S E R V I C E**N O T E**

Supersedes:
E8358A-02B

E8358A PNA Series RF Network Analyzers

Serial Numbers: 00000000 thru 46999999

Figure 1

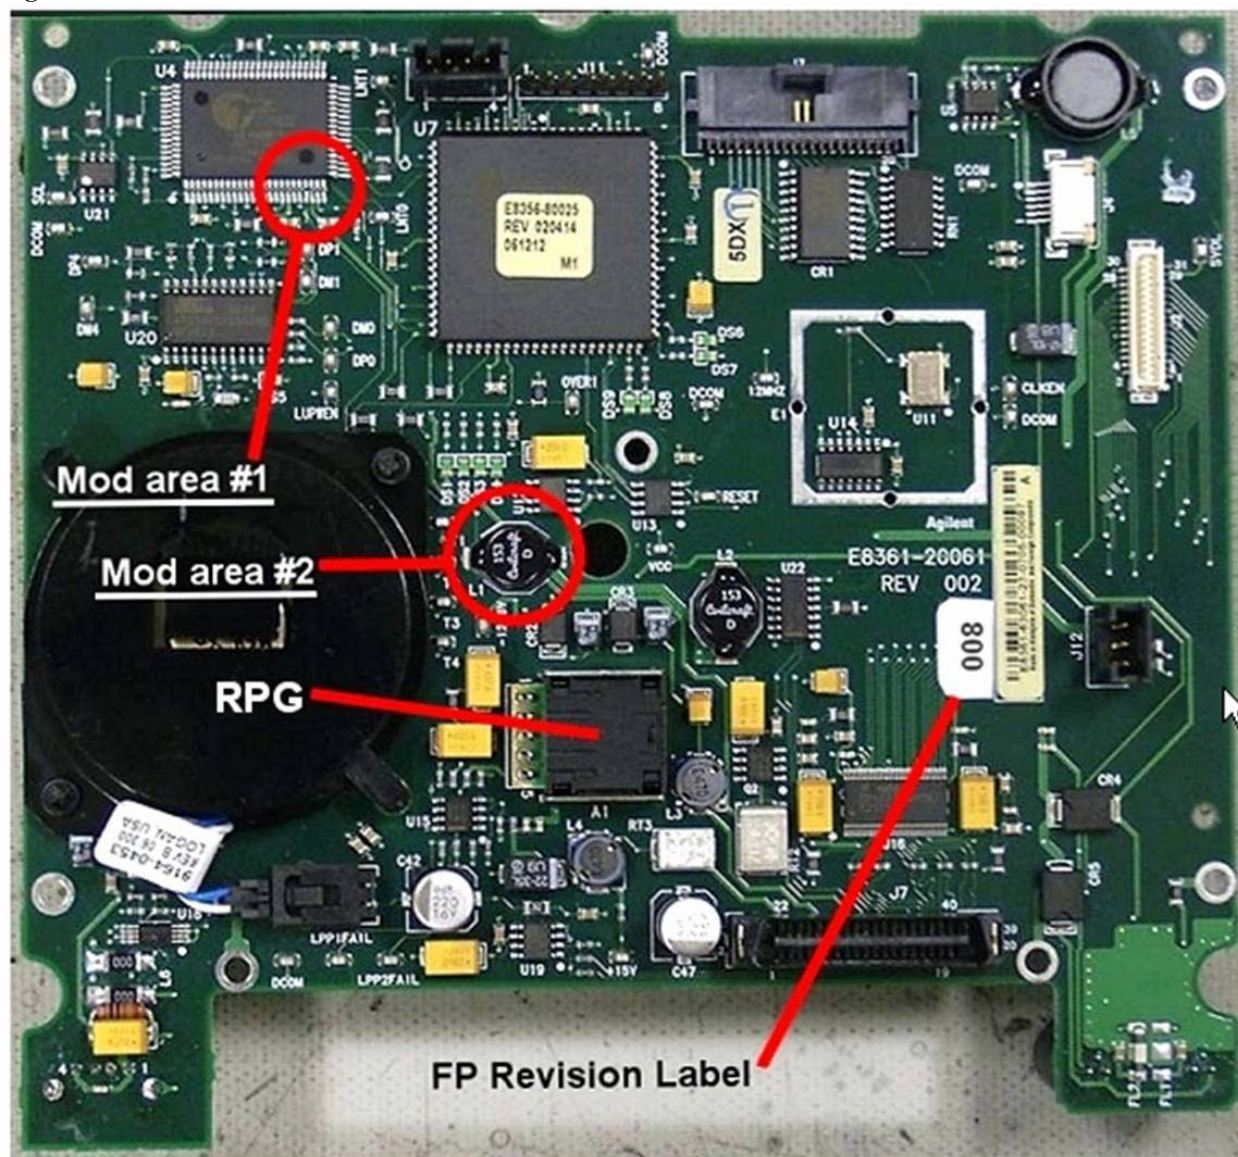
Refer to Figure 1 for the two modification areas to be addressed. Note that while this picture happens to show the FPI board completely removed from the front frame assembly, this is not necessary to perform the required modifications.

- Modification #1 consists of shorting two pins of U4 together with a small amount of solder.
- Modification #2 consist of removing L1.

Unsolder and completely remove the black surface mount inductor L1 from the front panel assembly board. This is no longer needed and can be discarded.

Figure 2

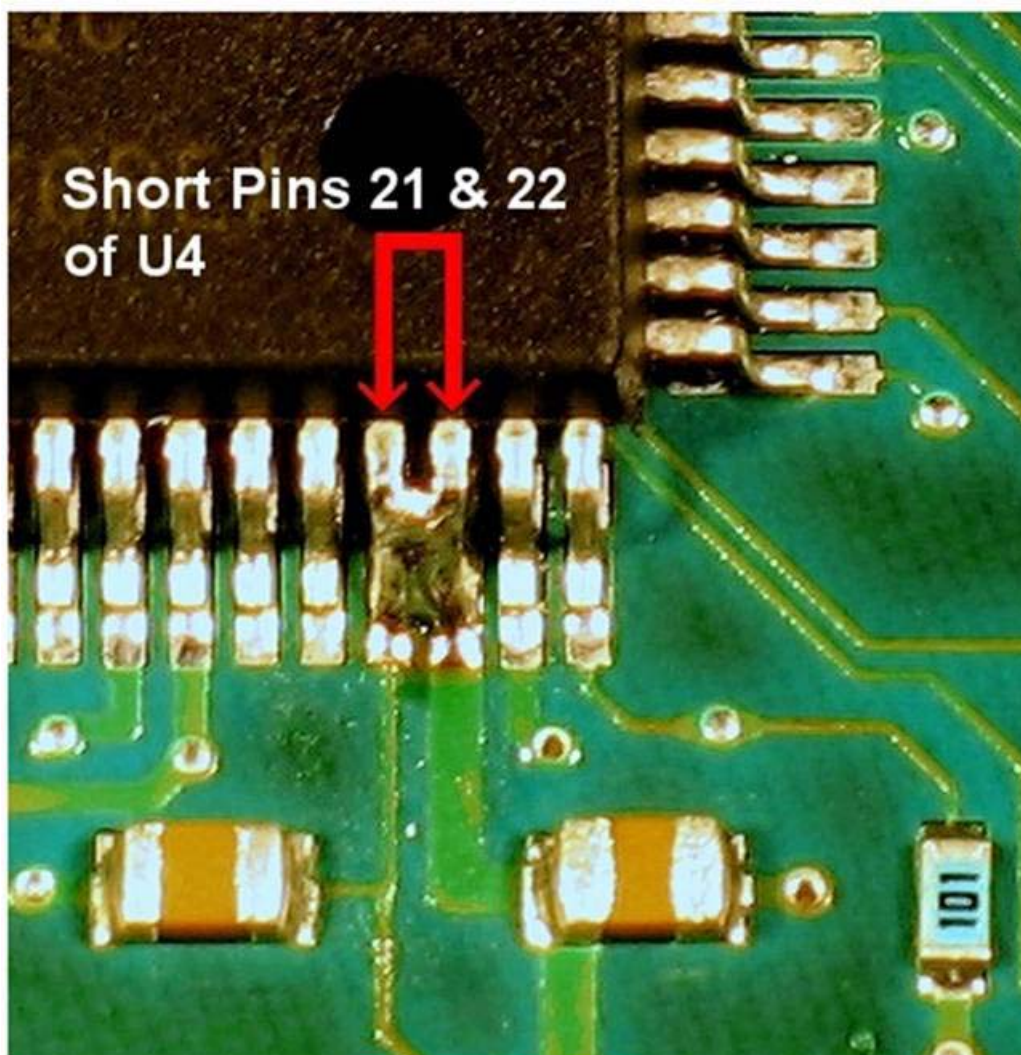
Carefully solder pins 21 and 22 together on U4. Refer to Figure 2 for the exact location. Use care so that no other pins are shorted. Use of a very fine tip soldering iron is recommended and a large work-task magnifying glass is very helpful.
